**Re: Revised Figure for Addendum No. 1 to
Removal Action Work Plan - Upper ½ Mile Reach of Housatonic River
General Electric Company, Pittsfield, Massachusetts**

GENERAL ELECTRIC COMPANY
PITTSFIELD, MASSACHUSETTS
REMOVAL ACTION WORK PLAN -
UPPER 1/2-MILE REACH OF HOUSATONIC RIVER

FIGURE
7-1D

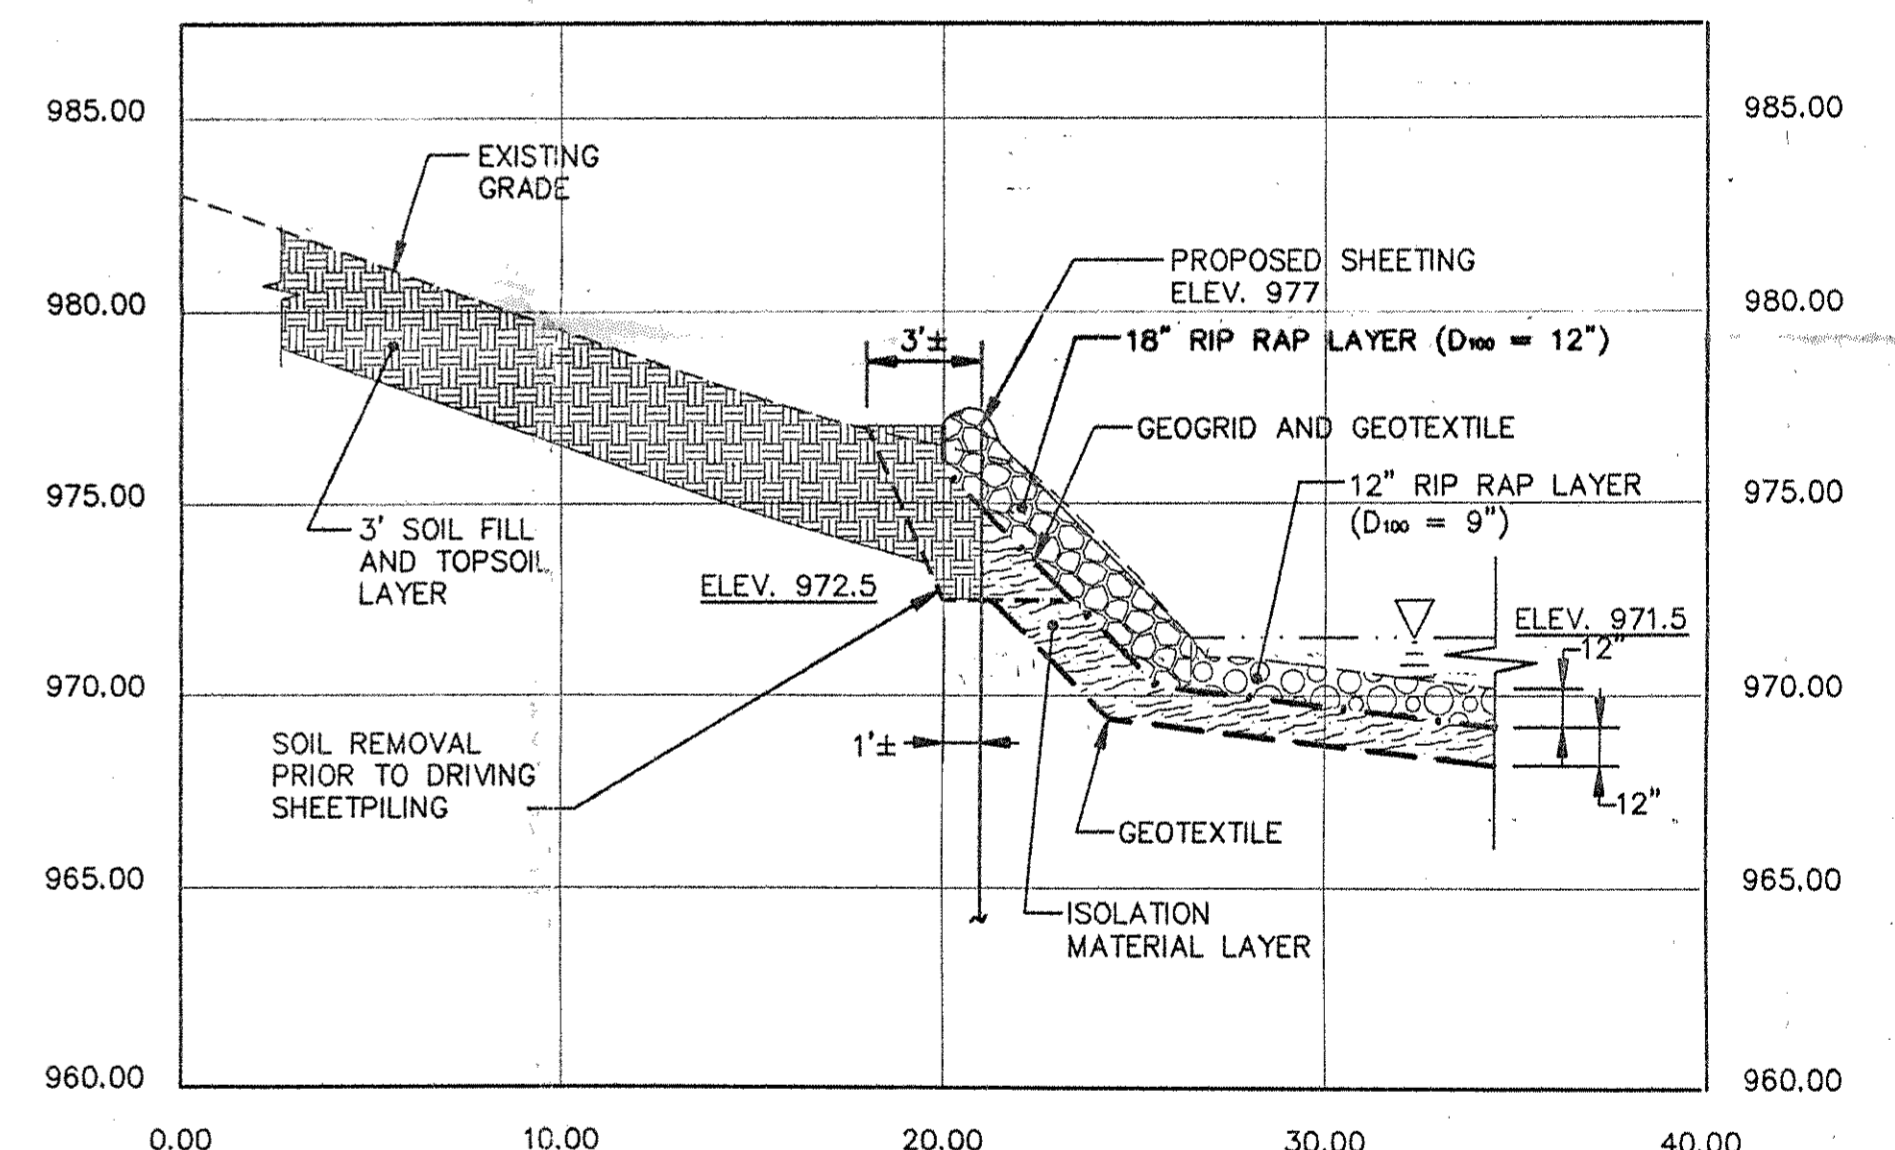
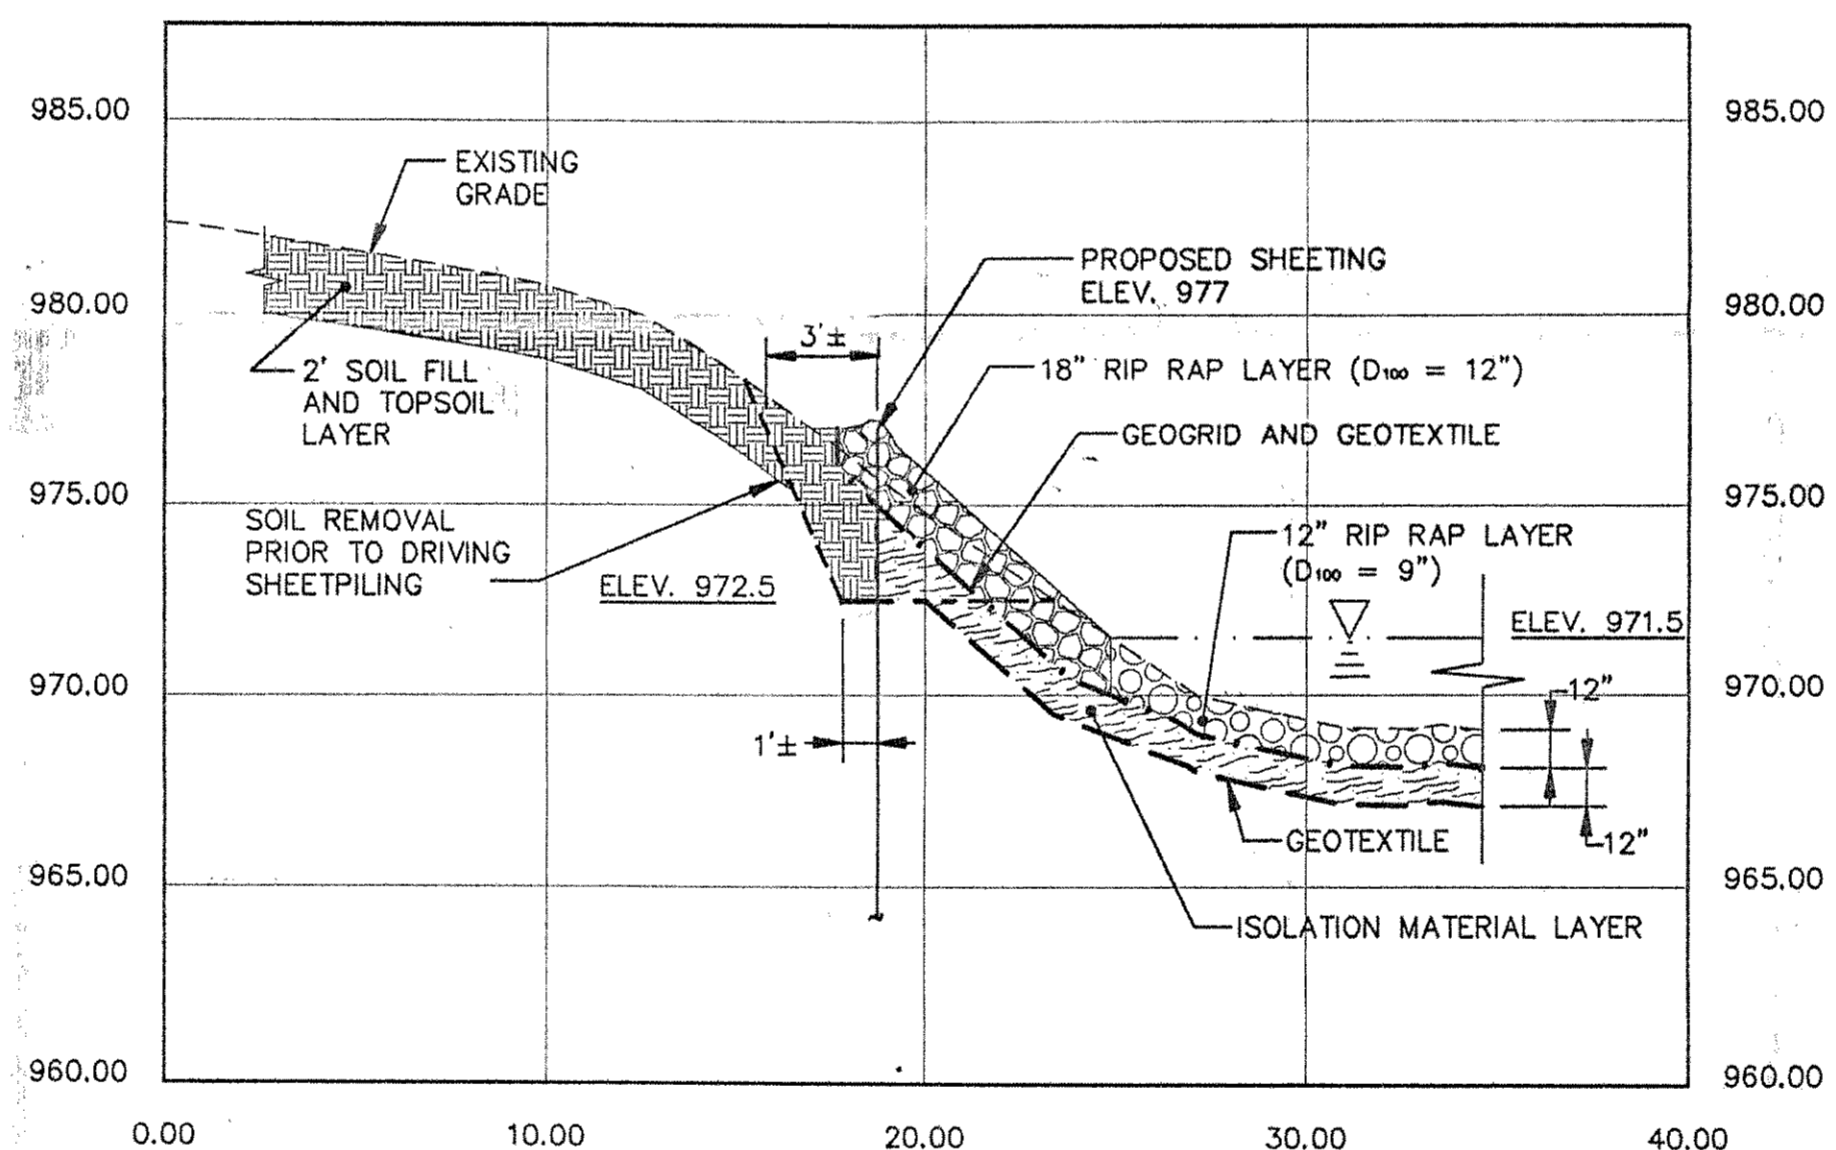
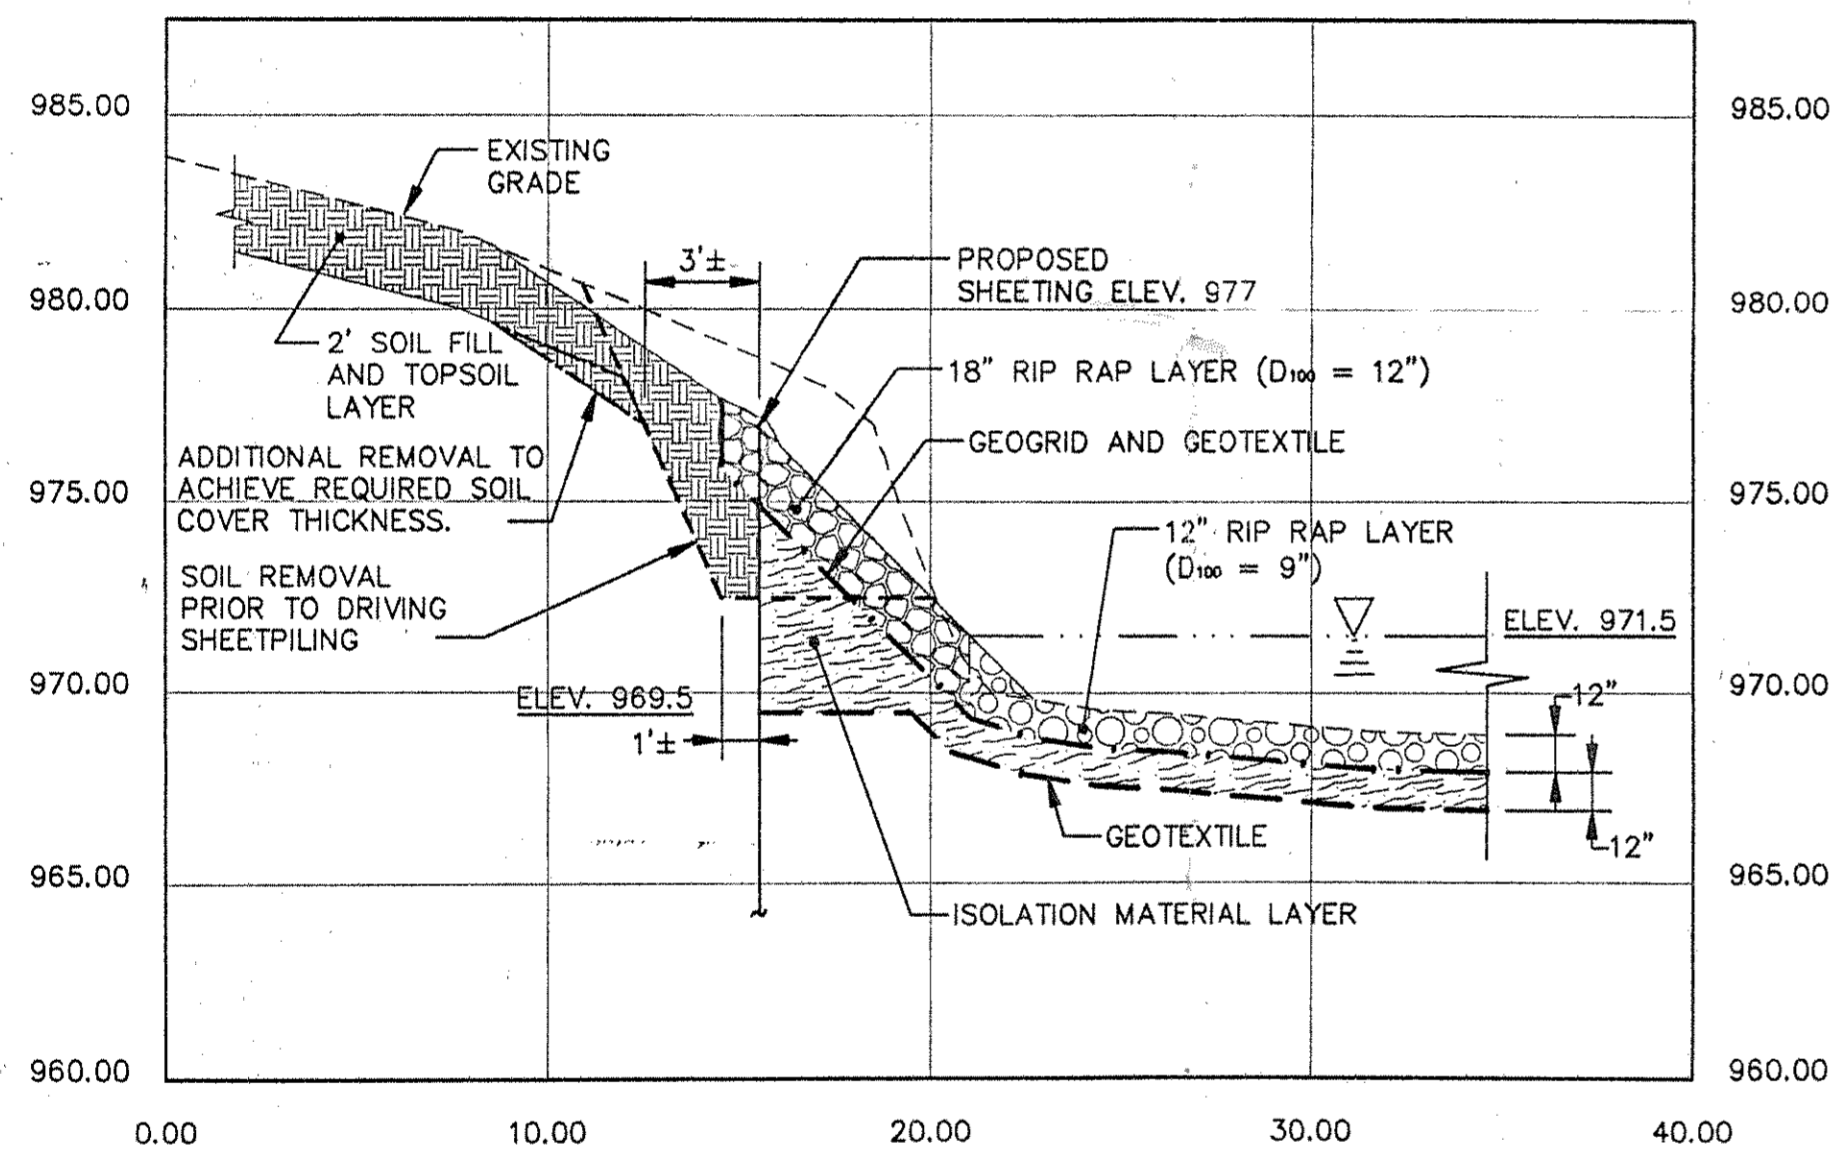
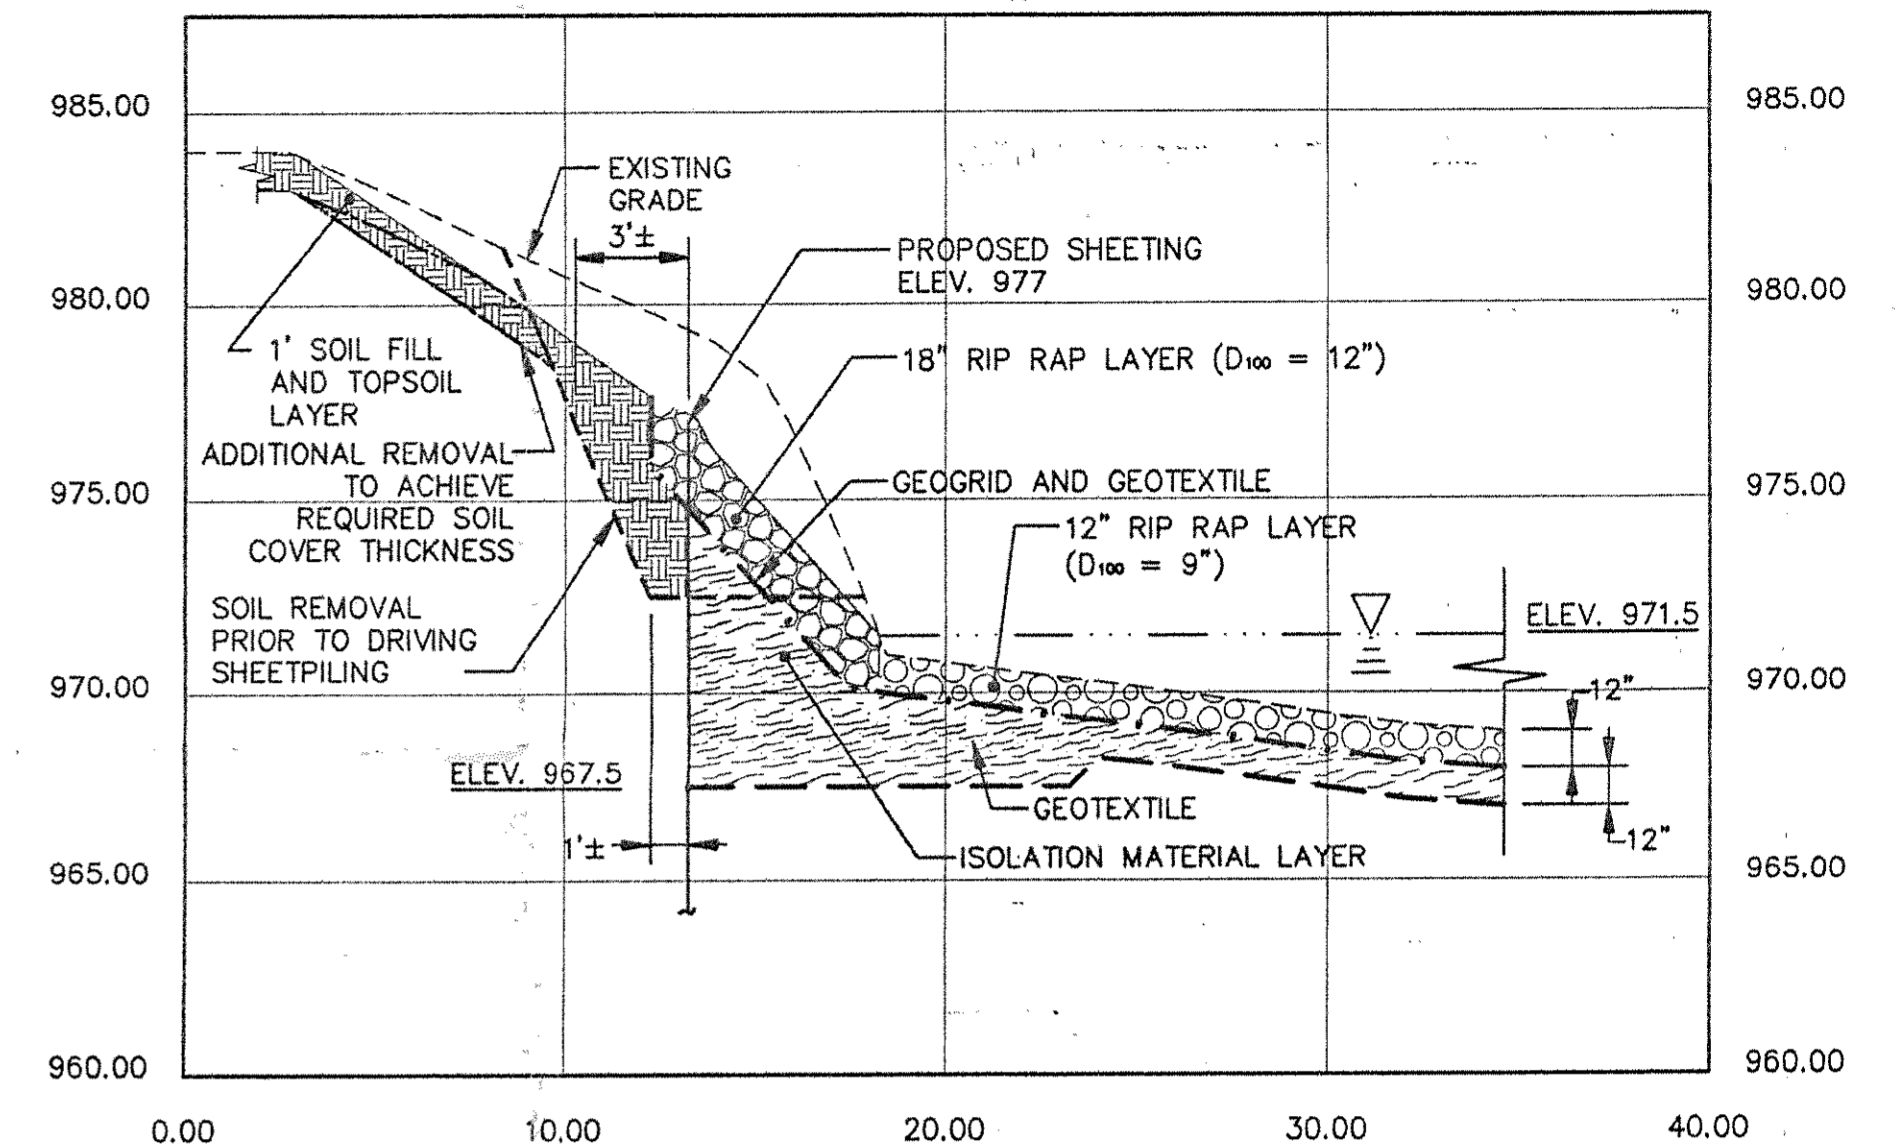
On November 4, 1999, the General Electric Company (GE) submitted an addendum (Addendum No. 1) to GE's *Removal Action Work Plan - Upper ½ Mile Reach of Housatonic River* [Blasland, Bouck & Lee, Inc. (BBL), August 1999]. That Addendum No. 1 presented information on two figures (Figure 4-4 and Figure 7-1D) associated with construction and restoration activities in the Upper ½-Mile Reach of Housatonic River adjacent to the Lyman Street Area (as defined in the Consent Decree). Subsequently, on December 3, 1999 EPA issued a letter to GE regarding Addendum No. 1 documenting GE's prior agreement with EPA to make certain modifications to Figure 7-1D of Addendum No. 1. In accordance with that letter, Figure 7-1D has been revised and is enclosed.

No.	Date	Revisions
1	11/4/99	ADDENDUM No. 1 -- SECTIONS V-V' THROUGH AA-AA'
2	1/7/00	REVISIONS PER EPA'S 12/3/99 LETTER

1. THE LOCATION OF THE SHEETPILE SHOWN IS APPROXIMATE AND WILL BE FIELD ADJUSTED BASED ON TOPOGRAPHIC CONDITIONS TO CREATE A MAXIMUM BANK SLOPE OF 1H:1V (I.E., NO STEEPER THAN A 1:1 SLOPE) FOR THE RESTORED BANK FROM THE RIVER'S EDGE TO THE TOP OF SHEETING.
